JOINT REGIONAL PLANNING PANEL (Sydney East Region)

JRPP No	2011SYE096
DA Number	MOD2012/0144
Local Government Area	City of Ryde
Proposed Development	Section 96(2) to amend the internal layout of Buildings B & C so as to accommodate more one bedroom apartments (change apartment mix), reduce height of lift overruns and minor reconfiguration of building footprint to reflect the changes in the apartment layouts.
Street Address	84-92 Talavera Road, Macquarie Park
Applicant/Owner	Karimbla Properties (No. 29) Pty Ltd
Number of Submissions	Nil
Recommendation	Approval
Report by	Sandra McCarry Senior Town Planner - Major Development

Assessment Report and Recommendation

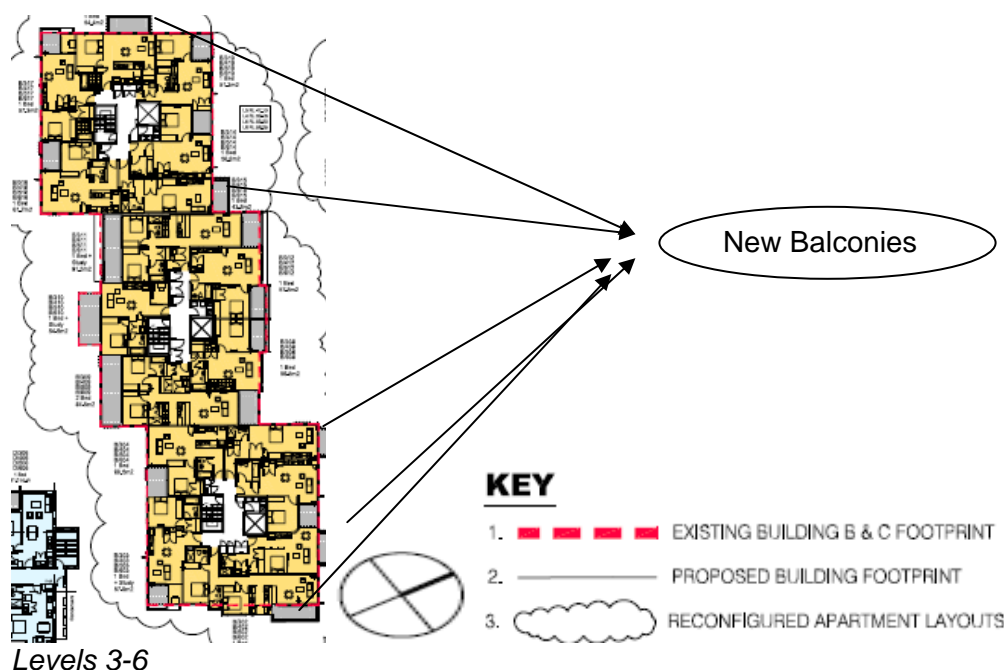
- The footprint will be amended on each level. On the ground level the south eastern corner and western corner will be extended. On the first and second level, the building floor is broken into two sections with a gap of between 9m and 10m wide to allow for a pedestrian walkway. The western section of the building will be amended by increasing the northwest corner of the building with the eastern elevation continued straight across to remove the entrance indentation. The eastern section of the building will be amended by extending the western elevation thereby reducing the separation between the two sections from 9m and 10m to between 6.6m to 8m. The north-west section of the building has been reduced with the paved courtyard areas for each of the apartments extended and the northeast corner of the building “squared off”. A new north facing balcony is proposed which extends outside the original building envelope.

- On levels three to seven a new balcony is proposed off the western elevation facing the M2 Motorway. Along the northern elevation, the

balcony area is reduced and the building “squared up” at the eastern corner by enclosing the balconies to provide additional floor space and new east facing balcony. New north facing balconies are also proposed. No changes are proposed along the southern elevation. Below is a typical layout of the proposed changes for levels three to six.

Levels 3-5

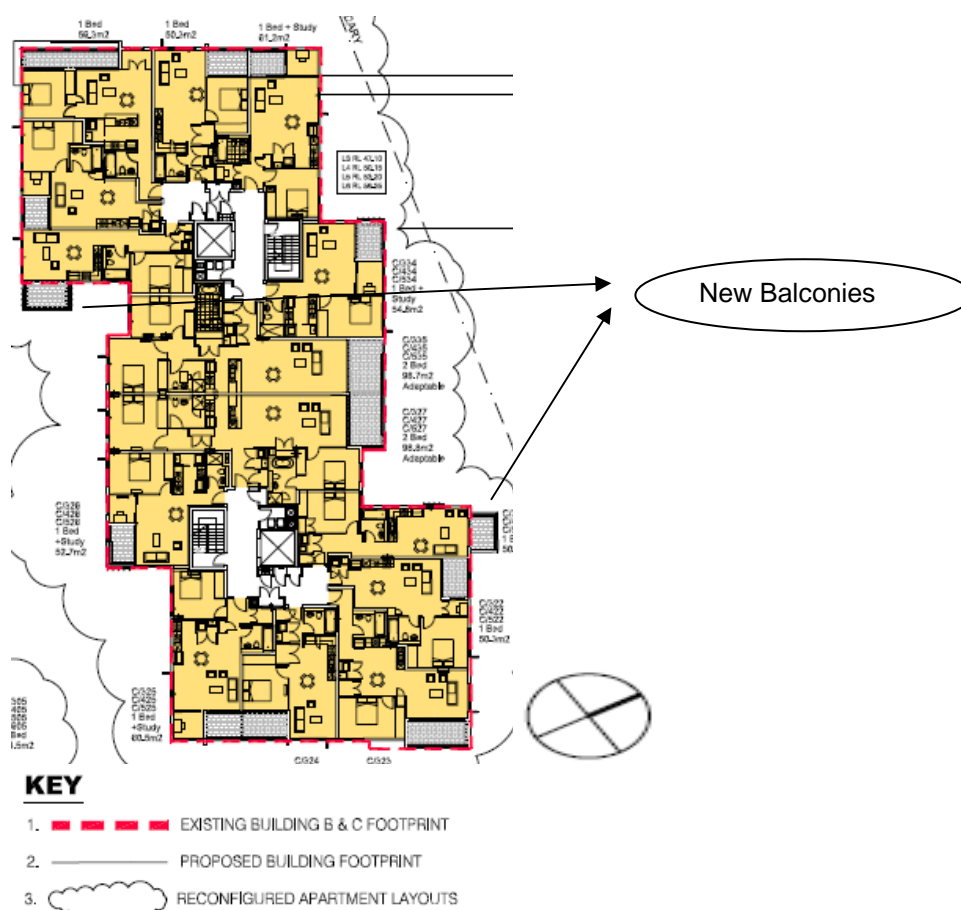
- On levels three to five, it is proposed to reconfigure the floor area along the eastern and western ends and add new balconies outside the building envelope at the south-western end of the building and the northern elevation. Below is a typical floor plan of levels three to five.
